# Access Compliance Report

## Public Rights-of-Way

### (Curb Ramps)

Intersection ID: 16083	Main Street: LLEWELLYN_PL	Cross Street: LOCKLEY_DR	Location: NE
ADA ID: A17382200BF6	Ramp Type: PerpDiag	Initial Pass/Fail: Fail	Overall Compliance: No
		Severity Score: 12.5

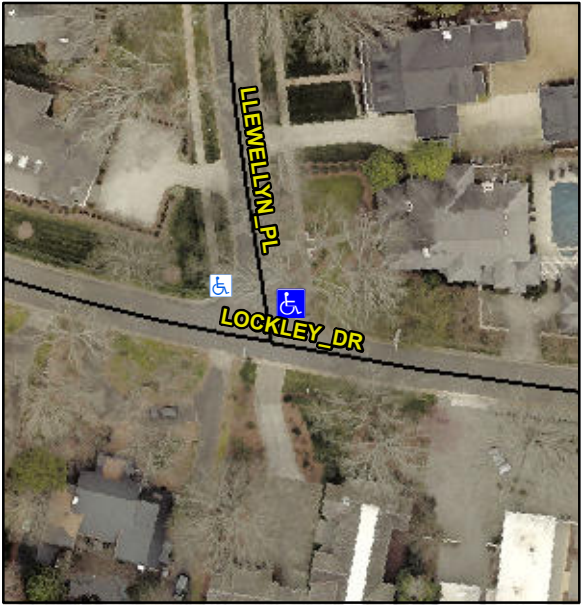
Codes/Mitigation Info/Possible Solution		Field Measurements/Component Compliance					
 <p>Street 1 Name: LLEWELLYN PL</p> <p>Stop Condition-Street 2: StopSign</p> <p>Street 2 Name: LOCKLEY DR</p> <p>Stop Condition-Street 1: None</p>	Possible Solutions:	Compliance	Description	Data	Compliance	Description	Data
	Remove & Replace Curb Ramp With Two New Directional Ramps or Equivalent.	N/A	Ramp Length (in)	105.0	No	Ramp Slope (%)	9.5
		Yes	Ramp Width (in)	55.0	Yes	Ramp XSlope (%)	2.0
		N/A	Flare Type LT	N/A	N/A	Flare Type RT	N/A
		N/A	Flare Slope LT (%)	N/A	N/A	Flare Slope RT (%)	N/A
		N/A	Flare Traversable LT?	N/A	N/A	Flare Traversable RT?	N/A
		N/A	Landing Length (in)	N/A	N/A	DWS Provided?	N/A
		N/A	Landing Width (in)	N/A	N/A	DWS Contrast?	N/A
		N/A	Landing Slope (%)	N/A	N/A	DWS Length (in)	N/A
		N/A	Landing X Slope (%)	N/A	N/A	DWS Full Width?	N/A
		N/A	Landing Curb? (Y/N)	N/A	N/A	DWS Offset (in)	N/A
		N/A	Shared Landing?	N/A

N/A	Gutter Ponding?	N/A	N/A	Gutter Slope (%)	N/A
		N/A	Gutter Lip Ht (in)	N/A	N/A	Gutter X Slope (%)	N/A
		N/A	Painted X Walk1?	No	N/A	Painted X Walk2?	No
			X Walk 1 Direction	To NW		X Walk 2 Direction	To S
		N/A	X Walk 1 Width (in)	N/A	N/A	X Walk 2 Width (in)	N/A
			X Walk 1 Slope (%)	2.3		X Walk 2 Slope (%)	0.6
			X Walk 1 X Slope (%)	1.0		X Walk 2 X Slope (%)	0.1
		N/A	Ramp inside XWalk1?	N/A	N/A	Ramp inside XWalk2?	N/A
<p>Surveyor Notes:</p> <p>N/A</p> <p>PROW/ADA:</p> <p>R304.2.2</p>			Road Slope (%)	2.7	N/A	Clear Space?	N/A
			Road X Slope (%)	5.4	N/A	Clear Space to XWalk (in)	N/A
		N/A	Any Obstructions?	N/A	N/A	Storm Grate/Utility Hazard?	N/A
			Obstruction Type			Storm Grate/Utility Type	
				N/A			N/A
					Yes	Surface Condition? (G/P)	Good
Total Cost:		\$	3200.00
